NOTICE PLAN COMMISSION September 15, 2015

NOTICE PLAN COMMISSION September 15, 2015

TO: Plan Commission
FROM: Tom Hovel, Zoning Administrator/City Planner
Susan Badtke, Community Planner
DATE: September 10, 2015
SUBJECT: September 15, 2015 Plan Commission Items

SITE ARCHITECTURAL PLAN

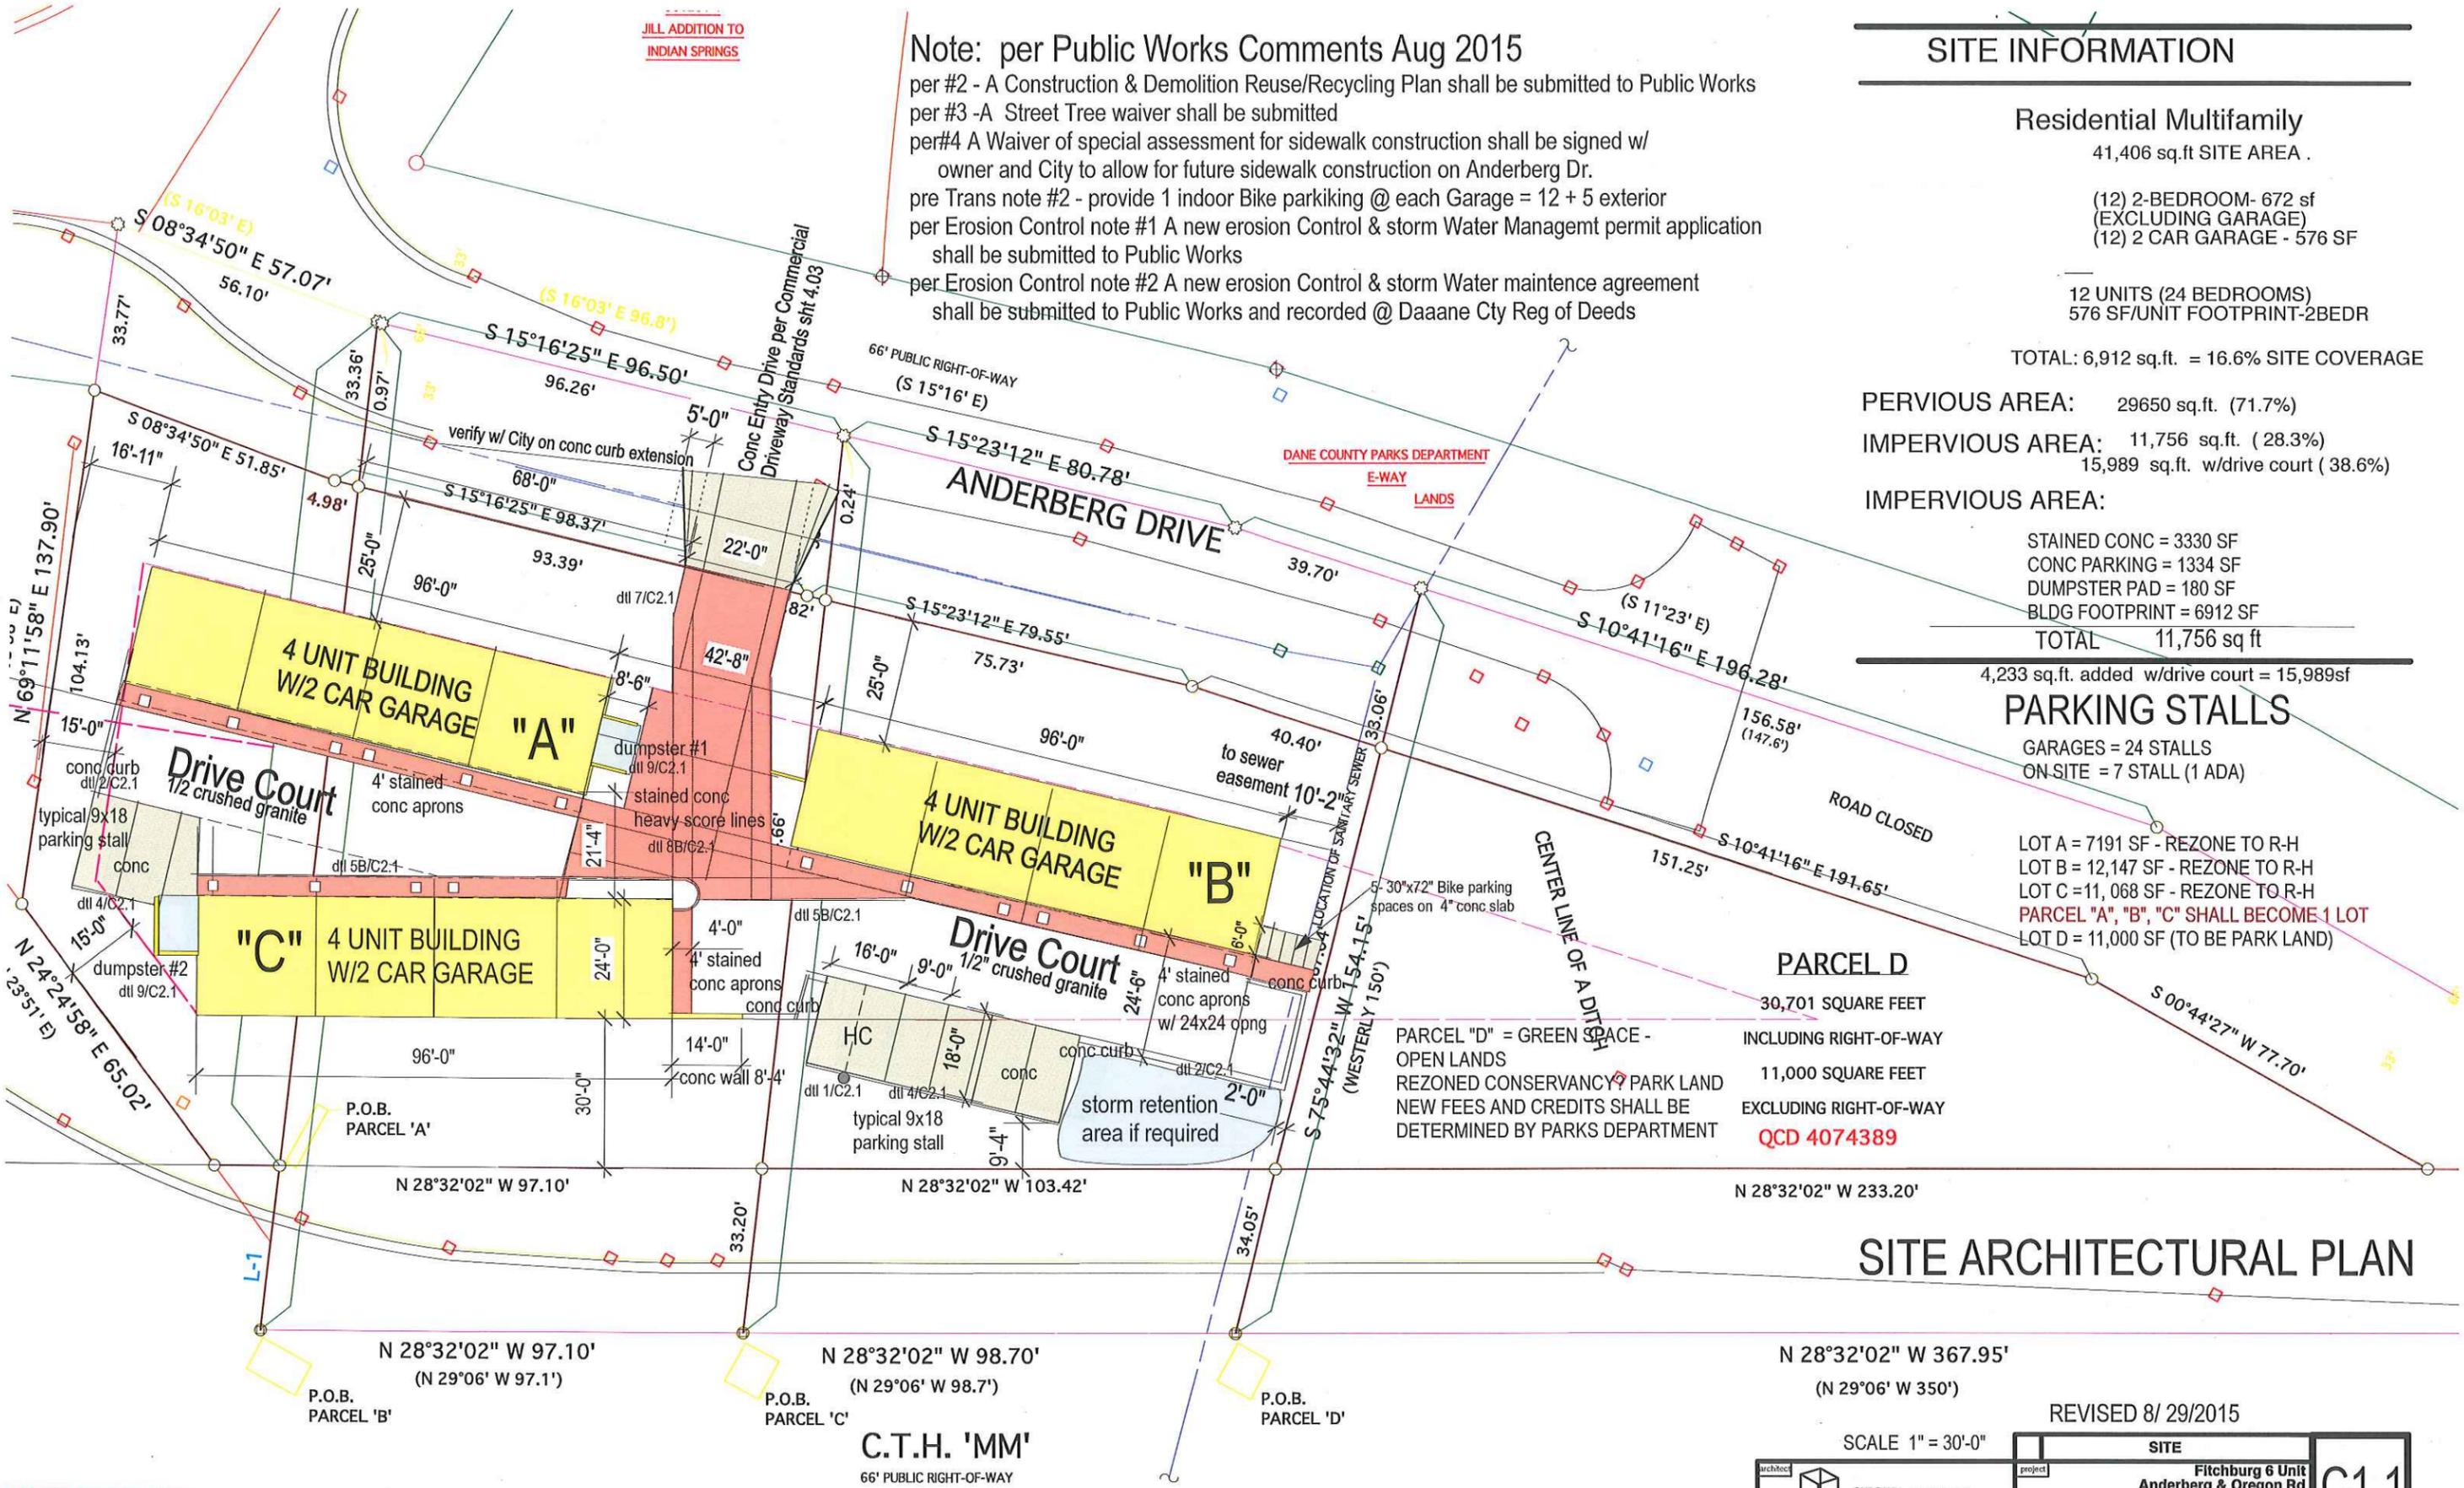
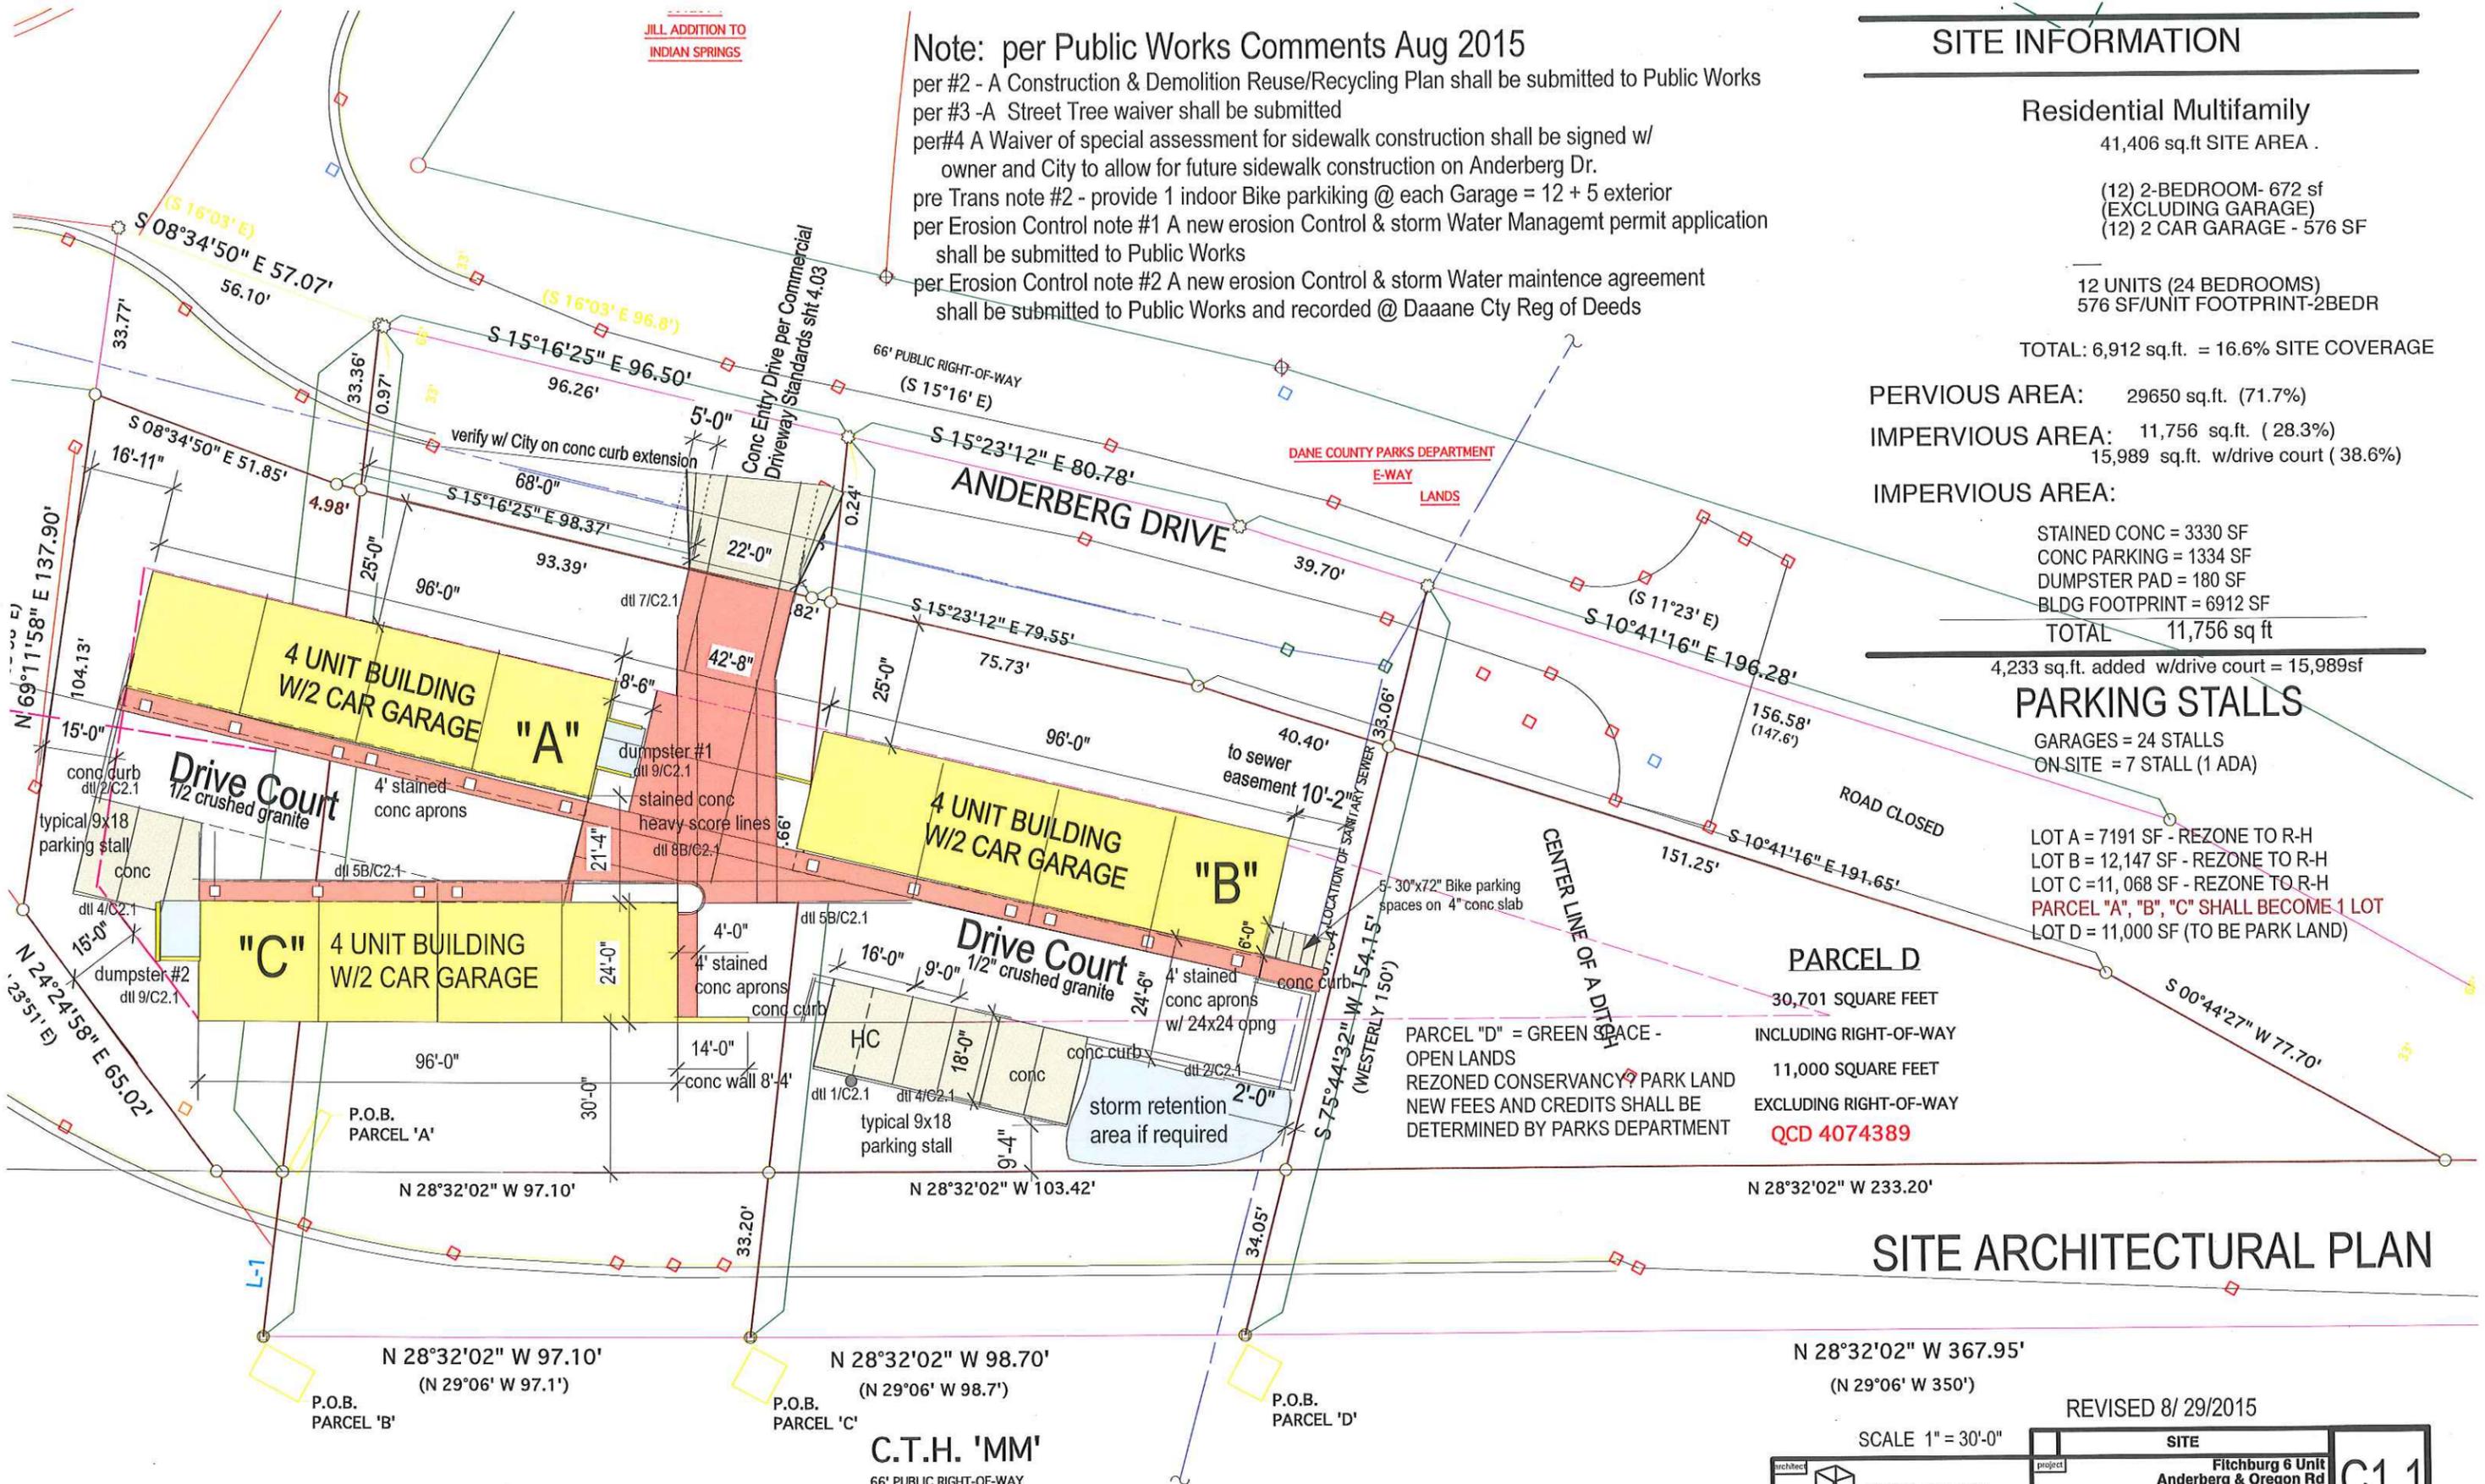
3. Sheet C1.1 shows two proposed parking stalls extending onto parcel D, which is the land to be dedicated for parkland. These stalls will need to be a minimum of two feet from the property line. There are two options:

- a. Adjust the parcel line for parcel D
 - b. Shift the parking stalls to the north
4. Please update the elevation drawing, sheet A4.1, to detail the building height as there is no scale on the drawing.
